14-02

**Air Conditioning Pressure Cutout
Switches – Schrader Valves Added –
Revised Torque Setting**

MODEL 1995 MY
Sedan Range
VIN 720001-ON

ILLUSTRATION 1

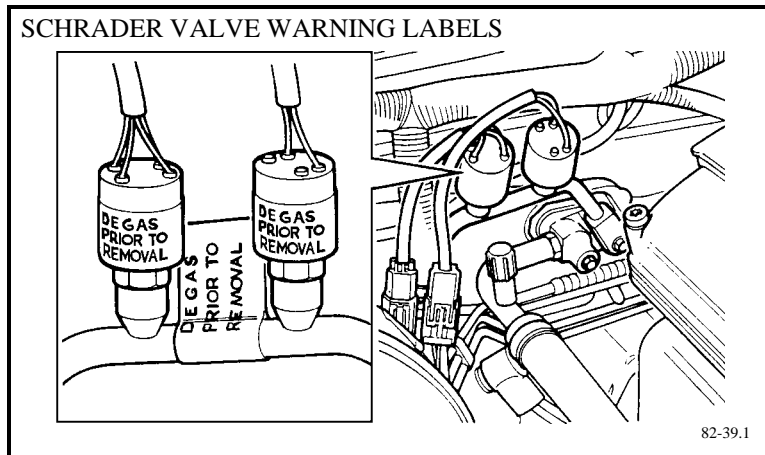
Vehicles within this VIN range may be labeled with a warning, “DEGAS PRIOR TO REMOVAL.” (Illustration 1)

Before removing the pressure switches on these vehicles always depressurize and recover the refrigerant.

- Depressurize both the high and low sides of the refrigerant system using approved R134a recovery equipment.

ALWAYS DEPRESSURIZE VEHICLES WITHIN VIN RANGE 720001 - 720579.
